A&A Leg Tutorial

Rev - Sept 23 2009
Part 6B added
No 6 and 6A reversed

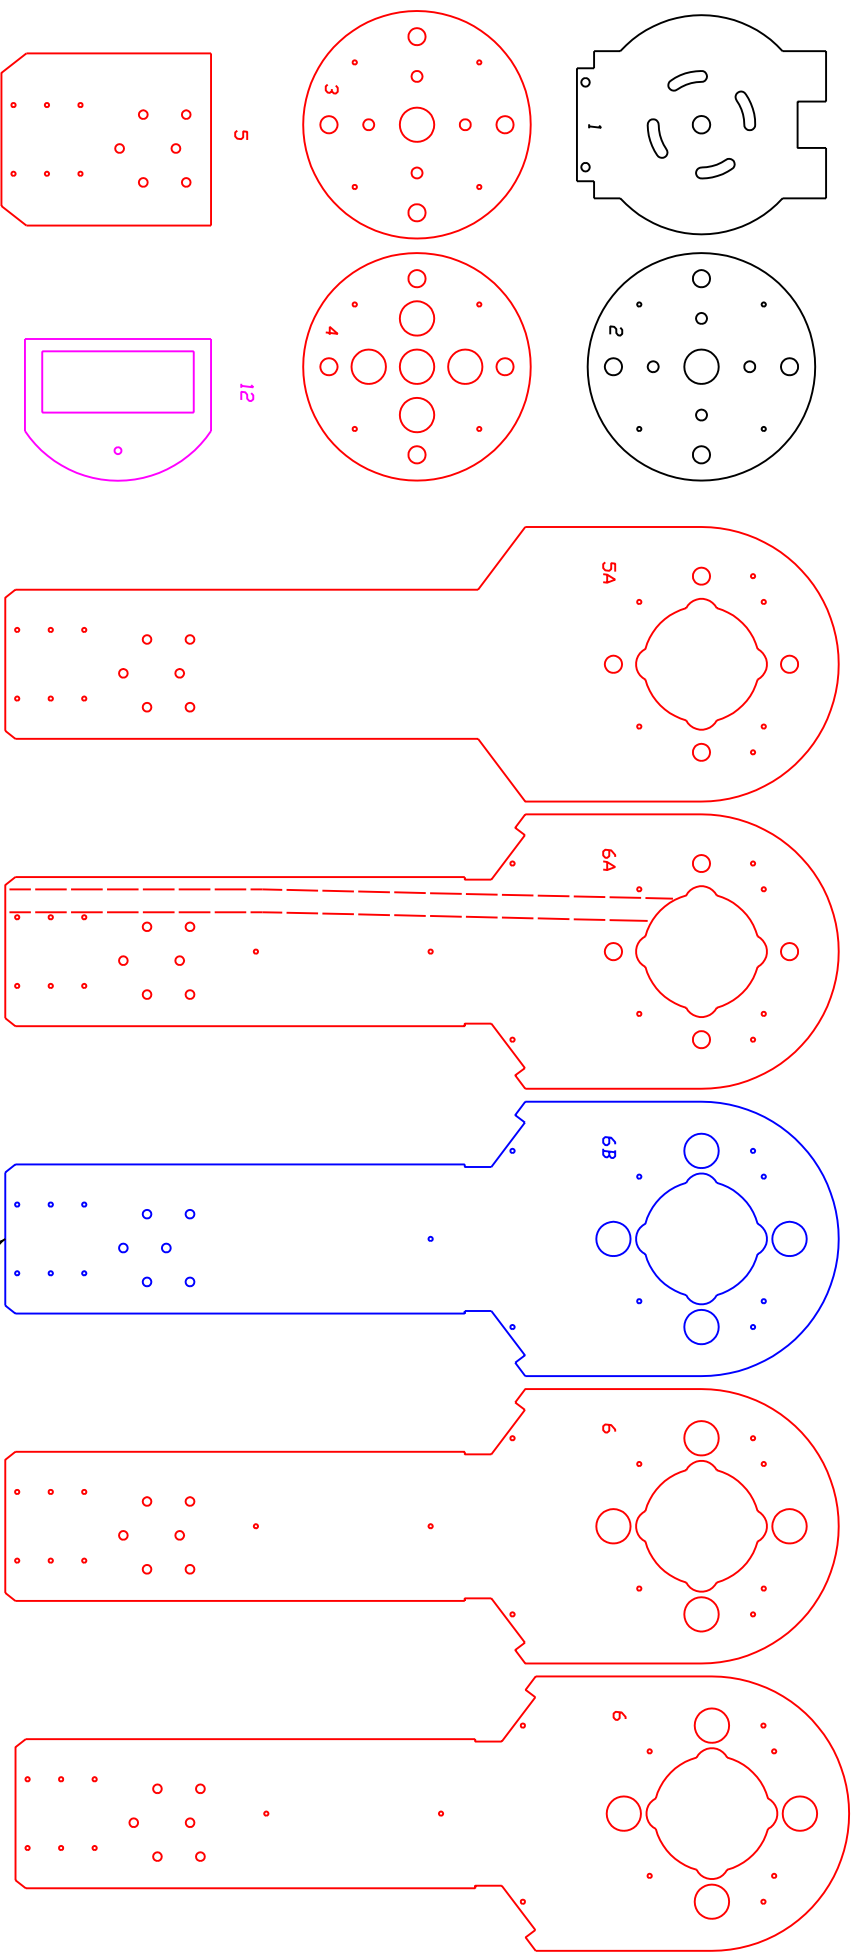
It was found that sometimes the thickness of the parts (ie 5A, 6, 6A etc) were not exactly 0.250". This meant the overall thickness was not correct. Part 6B is included to get the proper thickness if needed.
